RESOLUTION #JPA 17-24

A RESOLUTION OF THE MARCH JOINT POWERS COMMISSION OF THE MARCH JOINT POWERS AUTHORITY APPROVING PLOT PLAN (PP 17-03) AND FOUR CONDITIONAL USE PERMITS (CUP 17-04), (CUP 17-05) (CUP 17-06) AND (CUP 17-07), FOR THE DEVELOPMENT OF FIVE BUILDINGS ON UNIT 4, LOTS 5, 6 AND 7 WITHIN PLANNING AREA 7 OF THE MERIDIAN SPECIFIC PLAN AMENDMENT AREA (SP-5)

WHEREAS, MS Van Buren LLC c/o Silagi Development ("Applicant") proposes the development of 11.82 acres within Planning Area 7 of the Meridian Specific Plan Amendment (SP-5), including the development of 3 lots totaling approximately 176,396 square feet for Retail, Office and Warehouse uses ("Project"); and

Reduced Colored Site Plan

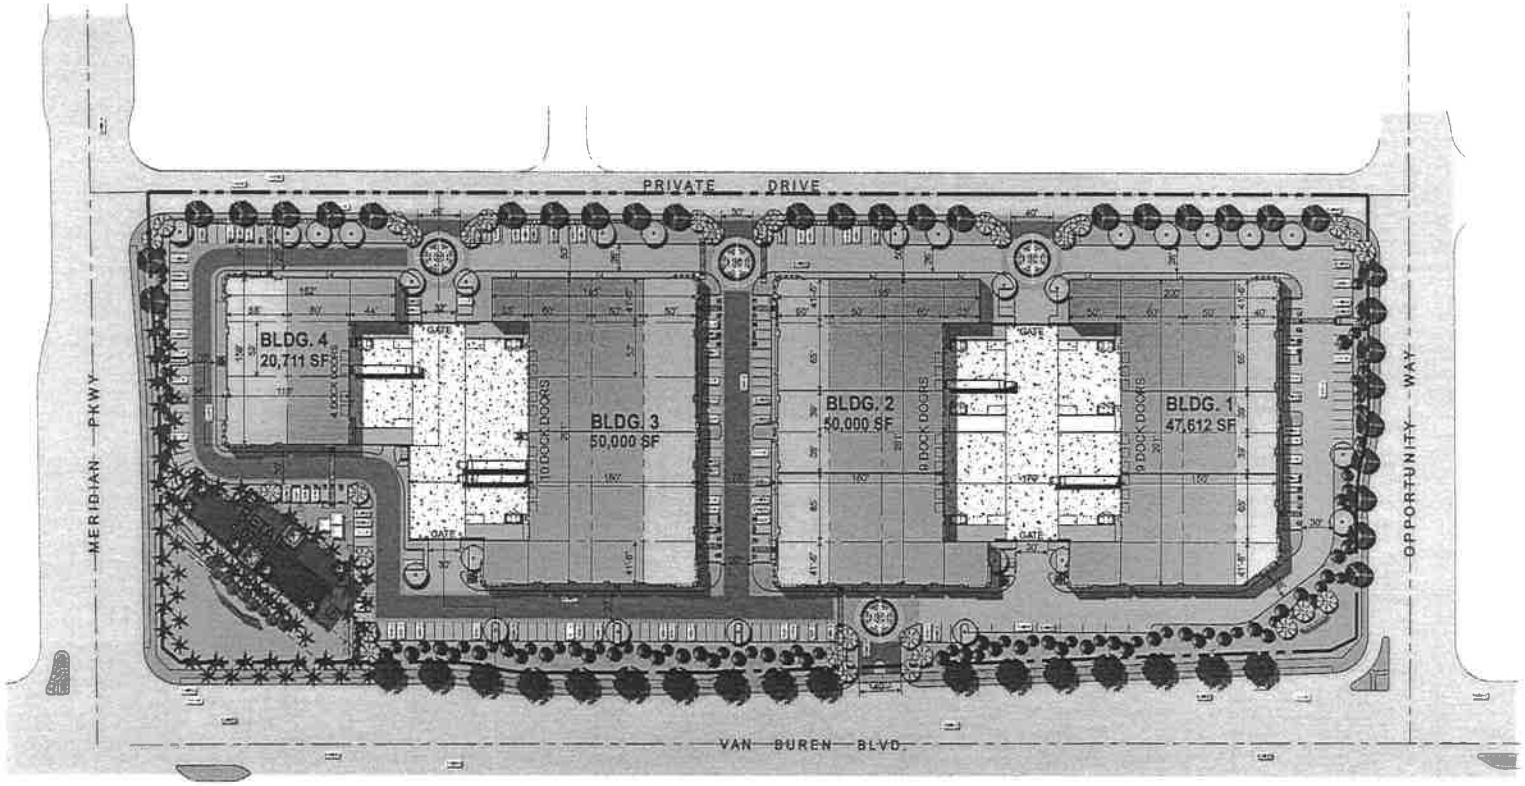
C-2
AIR QUALITY
PRIOR TO PLOT PLAN APPROVAL, PLEASE DETAIL IN SITE PLAN NOTES THAT EMPLOYERS SHALL IMPLEMENT A COMPRESSED WORKWEEK SCHEDULE WHEN FEASIBLE

H-7
UTILITIES AND SERVICES SYSTEMS
PLEASE DETAIL ON LANDSCAPE PLANS THAT THE PROJECT WILL PROPOSE A NON-POTABLE WATER SYSTEM THAT WILL MEET "PURPLE" PIPE STANDARDS FOR RECLAIMED WATER SYSTEMS.

H-8
UTILITIES AND SERVICE SYSTEMS
PLEASE DETAIL ON CONCEPTUAL DESIGN PLANS COMPLIANCE WITH MITIGATION MEASURE H-8 IN THAT "A FIREFLOW STANDARD OF 5,000 GALLONS PER MINUTE SHOULD BE USED FOR THE WATER DISTRIBUTION NETWORK

H-5
CLIMATE CHANGE AND GHG'S
PLEASE PROVIDED A SITE PLAN NOTE THAT ON-SITE TRASH ENCLOSURE SHALL PROVIDE THE FOLLOWING: GREEN WASTE ENCLOSURE, TRASH AND RECYCLABLE.

IV. L-1-14
CLIMATE CHANGE AND GHG'S
PRIOR TO PLOT PLAN APPROVAL, THE ARCHITECT MUST PROVIDE A SITE PLAN NOTE THAT THE PROJECT SHALL INSTALL ENERGY STAR LABELED ROOFING MATERIALS.

IV. L-1-15
CLIMATE CHANGE AND GHG'S
PRIOR TO PLOT PLAN APPROVAL, THE ARCHITECT MUST PROVIDED A SITE PLAN NOTE ENSURING THAT THE "PROJECT WILL ENCOURAGE THE USE OF MATERIALS THAT ARE RESOURCE SUFFICIENT, RECYCLED, WITH LONG LIFE CYCLES AND MANUFACTURED IN AN ENVIRONMENTALLY FRIENDLY WAY"

IV. L-1-18
CLIMATE CHANGE AND GHG'S
PRIOR TO PLOT PLAN APPROVAL, THE PROJECT SPONSOR/ARCHITECT SHALL DETAIL AS A SITE PLAN NOTE THAT "AN INCREASE OF EXTERIOR WALL INSULATION OVER TITLE 24 REQUIREMENT WILL BE ENCOURAGED". HOWEVER, A SPECIFIC PERCENT INCREASE IS NOT REQUIRED.

IV. L-1-19
CLIMATE CHANGE AND GHG'S
PRIOR TO PLOT PLAN APPROVAL, THE PROJECT SPONSOR/ARCHITECT SHALL DETAIL AS A SITE PLAN NOTE THAT "AN INCREASE OF ROOF INSULATION OVER TITLE 24 REQUIREMENTS WILL BE ENCOURAGED". HOWEVER, A SPECIFIC PERCENT INCREASE IS NOT REQUIRED.

IV. L-1-21
CLIMATE CHANGE AND GHG'S
PLEASE ENSURE THAT THE LANDSCAPE PLANS INCORPORATE THE FOLLOWING REQUIREMENT FOR ALL ON-SITE LANDSCAPE: "PARKING LOT AREAS WILL INCLUDE MIN. TREE COVERAGE (APPROXIMATELY ONE TREE PER EVERY FOURTEEN STALLS) FOR OFFICE USES AND 3E TREE COVERAGE (APPROXIMATELY ONE TREE FOR EVERY 20 STALLS) FOR INDUSTRIAL AND BUSINESS PARK USES WITHIN 10 TO 15 YEARS OF CONSTRUCTION. PROJECT WILL USE TREES THAT MATURE OVER A LONG TIME FRAME WITH LOWER WATER DEMAND. SHADE REQUIREMENTS WILL EXCLUDE TRUCK DOCKETS AND DRIVE AISLES"

IV. L-1.24
CLIMATE CHANGE AND GHG'S
PRIOR TO PLOT PLAN APPROVAL, PROVIDE DETAILS THAT ELECTRICAL OUTLETS WILL BE INSTALLED AT ALL BUILDING EXTERIOR AREAS AS PER MITIGATION MEASURE IV. L-1-24.

IV. L-1.25
CLIMATE CHANGE AND GHG'S
PRIOR TO PLOT PLAN APPROVAL, PLEASE PROVIDE A SITE PLAN NOTE THAT THE PROJECT WILL PROVIDE ENERGY EFFICIENT APPLIANCES (E.G. ENERGY STAR) AND ENERGY-REDUCING PROGRAMMABLE THERMOSTATS THAT AUTOMATICALLY ADJUST TEMPERATURE SETTINGS

IV. L-1.26
CLIMATE CHANGE AND GHG'S
PRIOR TO PLOT PLAN APPROVAL, THE PROJECT SPONSOR/ARCHITECT WILL PROVIDE A SITE PLAN NOTE THAT LOW FLOW AND WATERLESS FIXTURES WILL BE INSTALLED IN ALL PROPOSED RESTROOM FACILITIES AS PER MITIGATION MEASURE IV. L-1-26.
